ADDENDUM NO. 1

**TRI-COUNTY SCHOOL JR-SR HIGH SCHOOL BACKPACK ADDITION &
NEW MAINTENANCE FACILITY
Wolcott, IN 47995**

ADDENDUM ONE

Addendum One (AD.01) to the drawings and specifications prepared by Gibraltar Design for **Tri-County Jr/Sr High School Backpack Addition & New Maintenance Facility** for Tri-County School Corporation, Wolcott, Indiana.

11. Sheet E-201

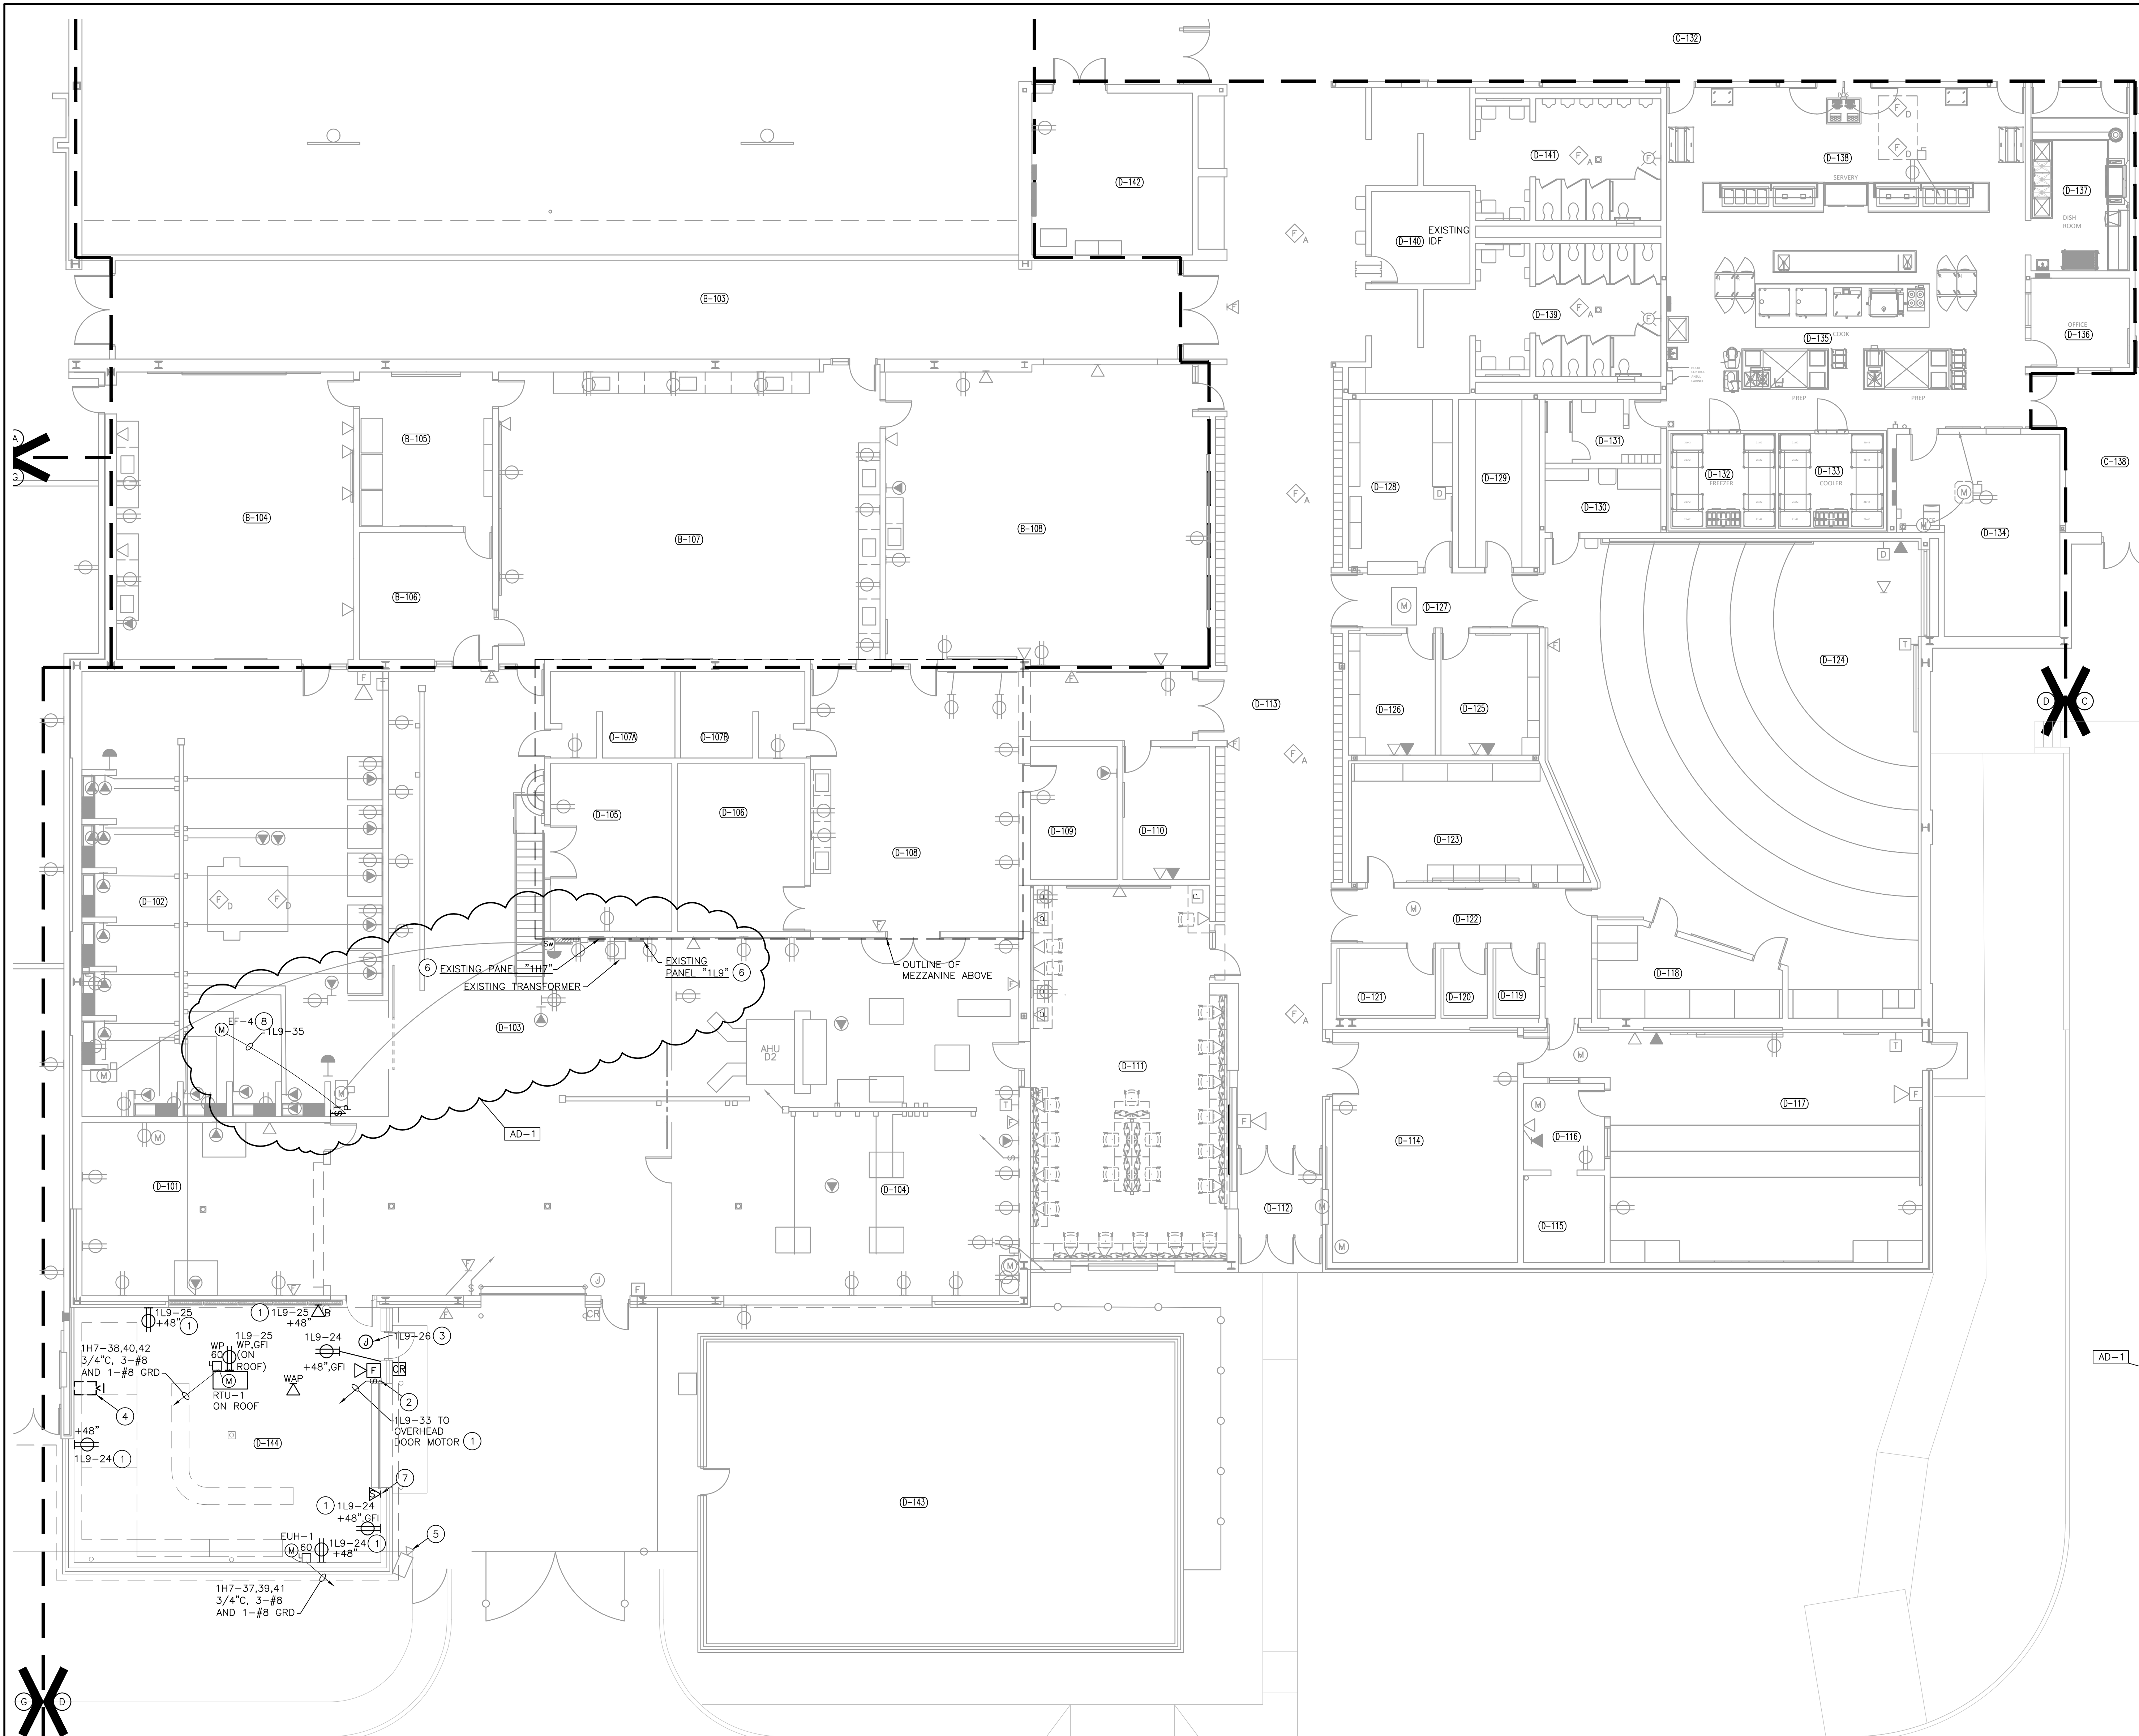
1. In Small Engine Shop D-103 added electrical connection for new exhaust fan.
